PLANNING BOARD REPORT PORTLAND, MAINE

Mixed-Use Development
23 Ocean Avenue
Level III Site Plan and Subdivision Review
23 Ocean Avenue Association, LLC

Submitted to: Portland Planning Board	Prepared by: Nell Donaldson, Planner
Date: October 21, 2016	CBL: 129-G-1
Public Hearing Date: October 25, 2016	Project #: 2016-120

Figure 4: Final site plan

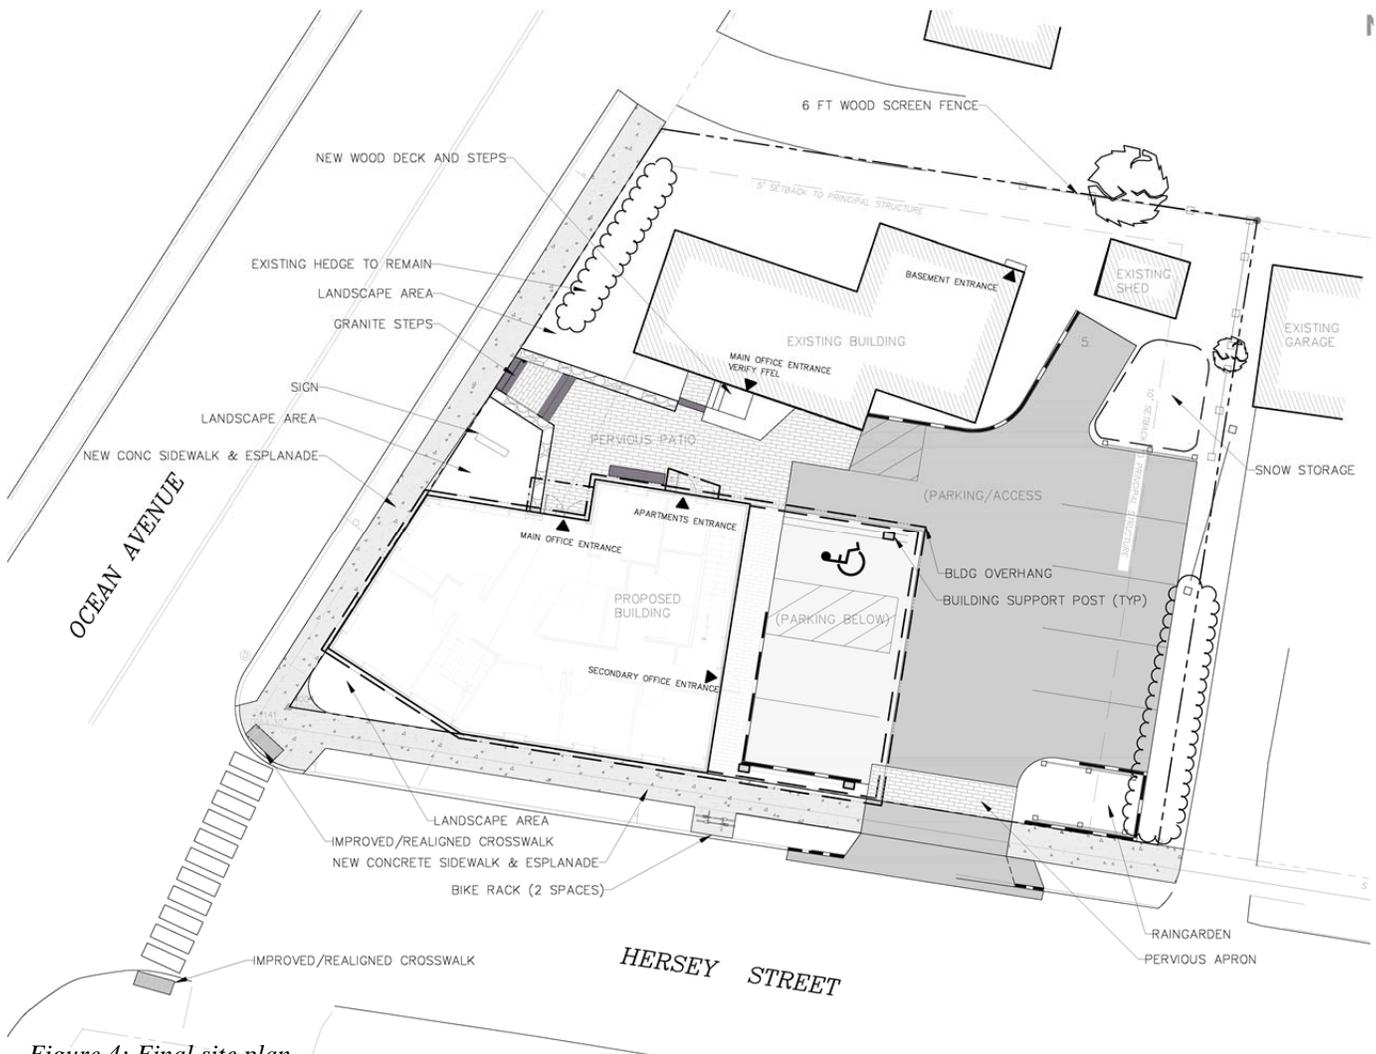
The final plans show continued use of an existing curb cut from Hersey Street for vehicular access. In the final plans, the applicant has reconfigured the parking area and reduced the number of proposed parking spaces by one as a means of eliminating the need for backing maneuvers to Hersey Street. The applicant has provided turning templates as documentation of the adequacy of the parking area design (*Plan 21*). The applicant has requested a waiver for parking lot aisle width. Mr. Errico writes,

The applicant has provided information that demonstrates onsite circulation can be accommodated.

Following a review of vehicle turning template information and revisions to the parking lot layout, I support a waiver from the City’s Technical Standards.

At the request of Jeff Tarling, the city’s arborist, the applicant has revised the landscape plans to show two zelkovas on the Ocean Avenue frontage, three Armstrong maples in the esplanade on Hersey Street, and a cherry tree at the corner of Ocean Avenue and Hersey Street. Collectively, these trees meet the city’s street tree requirement of one per unit. It should be noted that staff has recommended a condition of approval to address a potential conflict between the cherry tree and a stormwater treatment unit proposed for the Ocean Avenue/Hersey Street corner.

6. The applicant shall provide revised plans to address the conflict between the proposed cherry tree and stormwater treatment unit at the corner of Ocean Avenue and Hersey Street for review and approval by the City Arborist and the Planning Authority.
